# DEVELOPMENT APPLICATION ASSESSMENT REPORT

Application Number:	DA2019/1141	
Responsible Officer:	Rhiannon McLardy	
Land to be developed (Address):	Lot 39 DP 244404, 41 Sir Thomas Mitchell Drive DAVIDSON NSW 2085	
Proposed Development:	Alterations and additions to a dwelling house	
Zoning:	Warringah LEP2011 - Land zoned R2 Low Density Residential	
Development Permissible:	Yes	
Existing Use Rights:	No	
Consent Authority:	Northern Beaches Council	
Land and Environment Court Action:	No	
Owner:	David Nicholas Akers	
Applicant:	David Nicholas Akers

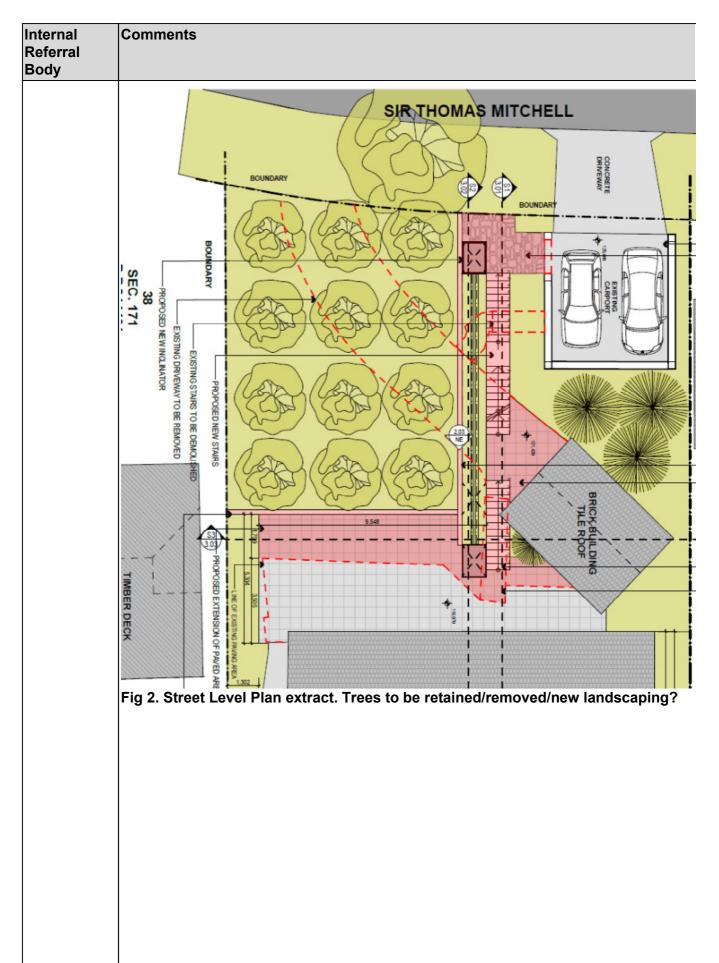
Internal Referral Body	Comments
Landscape Officer	Additional Information Comment 20/11/19 Amended plans and site photos are noted.
	Trees proposed to be removed are now indicated on the plans and it is noted that exemp to be removed, with others retained.
	No objections are raised to approval subject to conditions as recommended.
	Original Comment

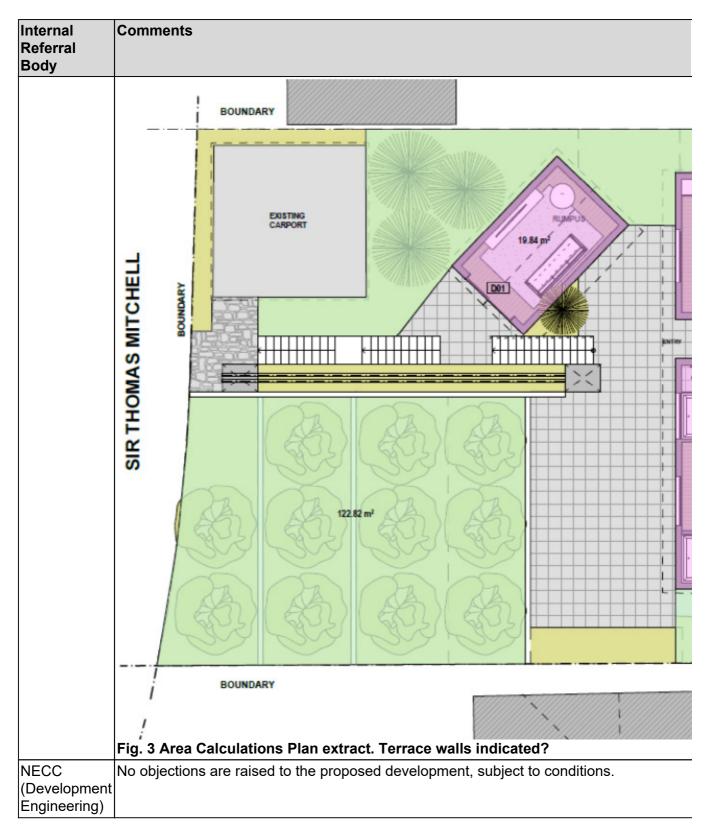
Internal Referral Body	Comments					
	The plans indicate construction works in the front of the property. The SEE indicates that be removed, however comparison between the Survey Plan and the Street Level Plan (e that a number of large trees will be required to be removed to accommodate the works. T does not identify existing or proposed trees or trees to be removed. The Area Calculation indicate terrace walls on the western side of the site. Additional information is required to identify trees to be removed and retained and proposed					
	the front of the site. If the above could be clarified, further assessment can be undertaken.					
	Image: constrained state in the state
